**POLARIS**

# TECHNICAL SERVICE BULLETIN

Bulletin Number: L-17-01-A/B  
Model Years: 2016-2017

#### 2016-2017 GEM STEEL WHEEL LUG NUT TORQUE

**AFFECTED**

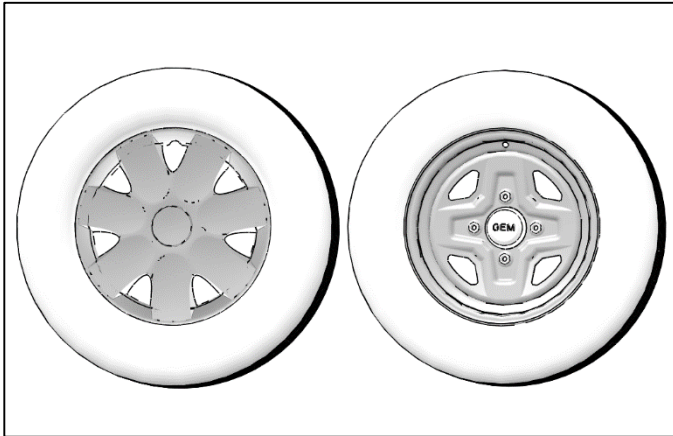
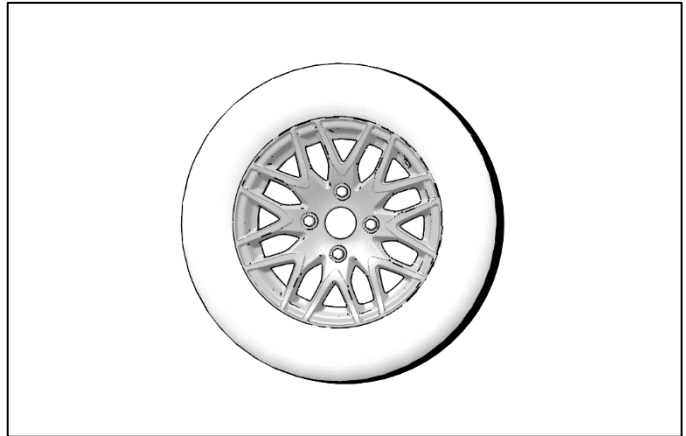
On some models equipped with steel wheels, the wheel lugs may become loose over time, which may allow the wheel to separate from the vehicle and pose a safety hazard. Vehicles with aluminum wheels are not affected by this concern.

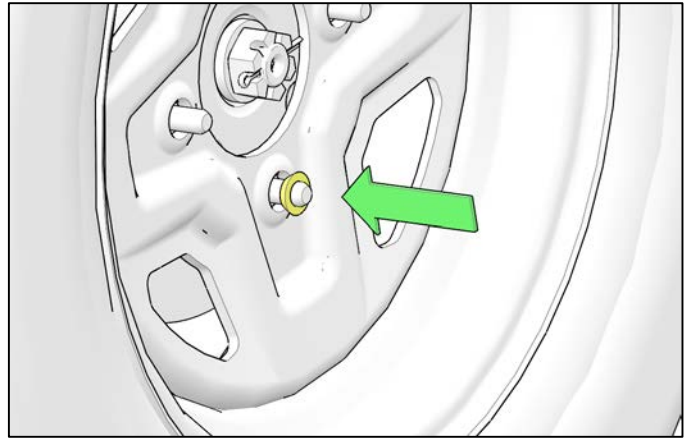
11. Install new cone washers, taper facing inward as shown.

Ensure that the rim, cone, and wheel studs are clean and free of any foreign substance or lubricants.

### TORQUE

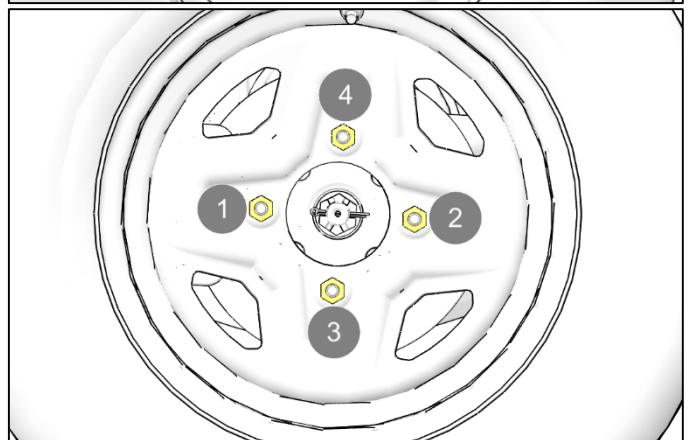
15. Torque lug nuts to specification in the sequence shown.

Wheel Lug Nuts  
**50 ft-lbs (68 Nm)**

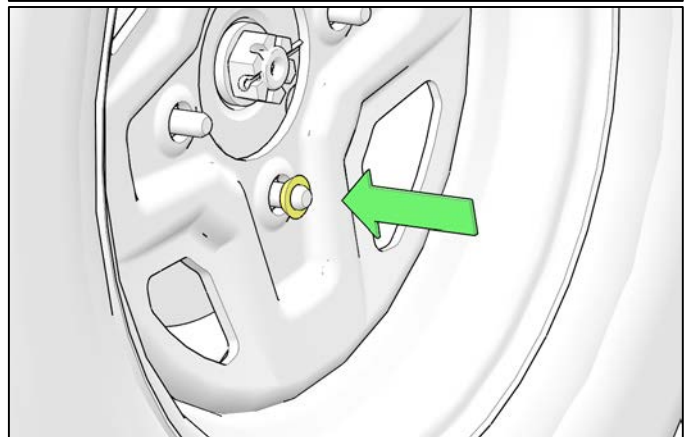
23. Install new cone washers, taper facing inward as shown.

Ensure that the rim, cone, and wheel studs are clean and free of any foreign substance or lubricants.

**TORQUE**

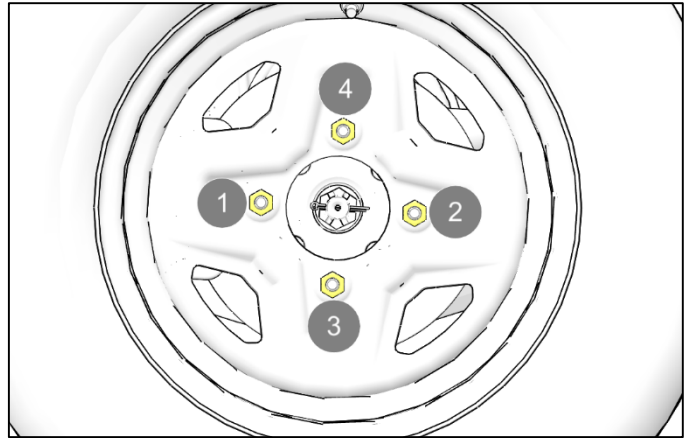
27. Torque lug nuts to specification in the sequence shown.

Wheel Lug Nuts  
**50 ft-lbs (68 Nm)**

#### Front Wheels

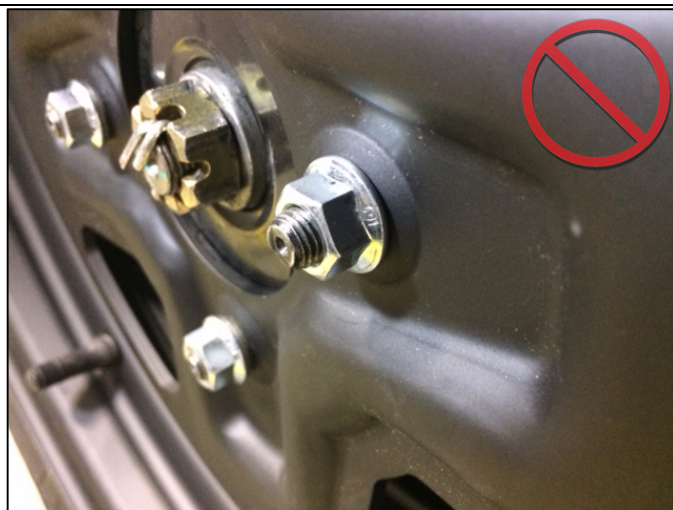
**ACCEPTABLE** – Washer is installed correctly and flange nut does not make contact with the rim.

**UNACCEPTABLE** – Washer is installed backwards.

**UNACCEPTABLE** – Washer was not installed and flange nut is contacting rim.

A secondary dealer representative must verify that all sixteen flange nuts are raised off of the rim, and do not make contact with the rim. Then mark each lug nut with a paint pen.

## Rear Wheels

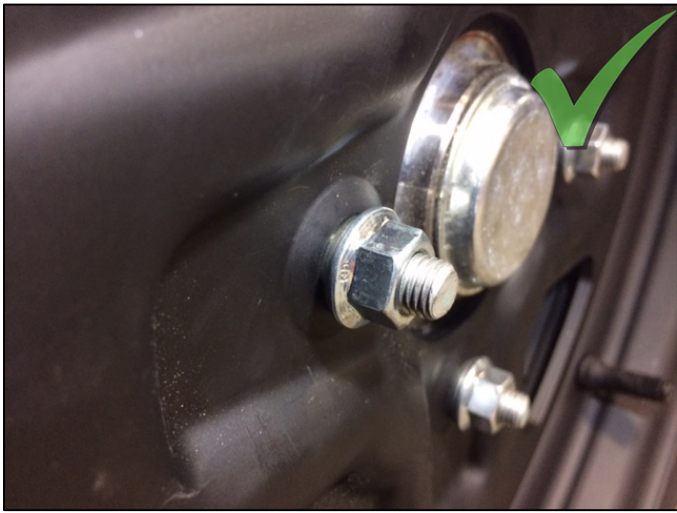
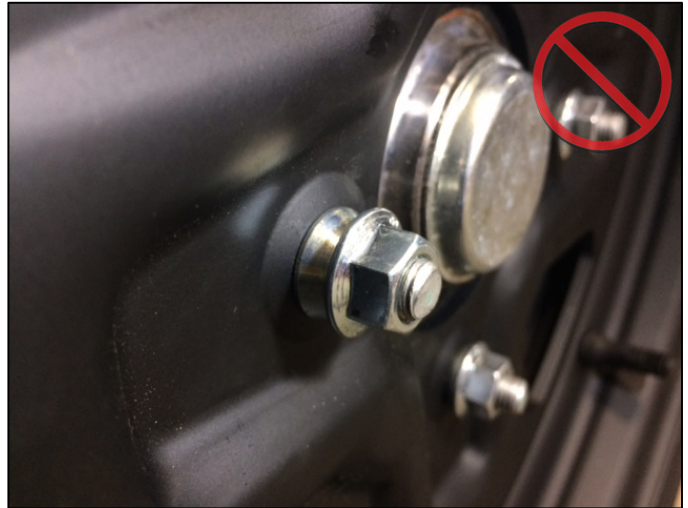
**ACCEPTABLE** – Washer is installed correctly and flange nut does not make contact with the rim.

**UNACCEPTABLE** – Washer is installed backwards.

**UNACCEPTABLE** – Washer was not installed and flange nut is contacting rim.

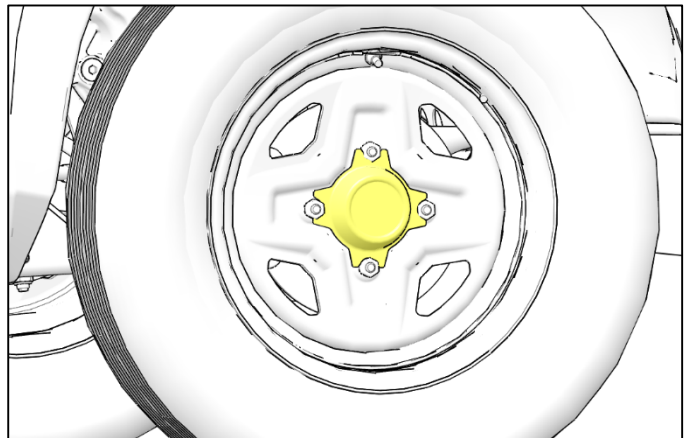
28. Reinstall wheel covers, if equipped.
29. **For eL XD models only:** Install new hub caps (P/N 5454794) by tucking each wing of the hub cap under each flange nut, one at a time.

Do NOT loosen lug nuts to install the new hub caps (P/N 5454794) hub caps MUST be installed AFTER lug nuts are installed and torqued to specification.
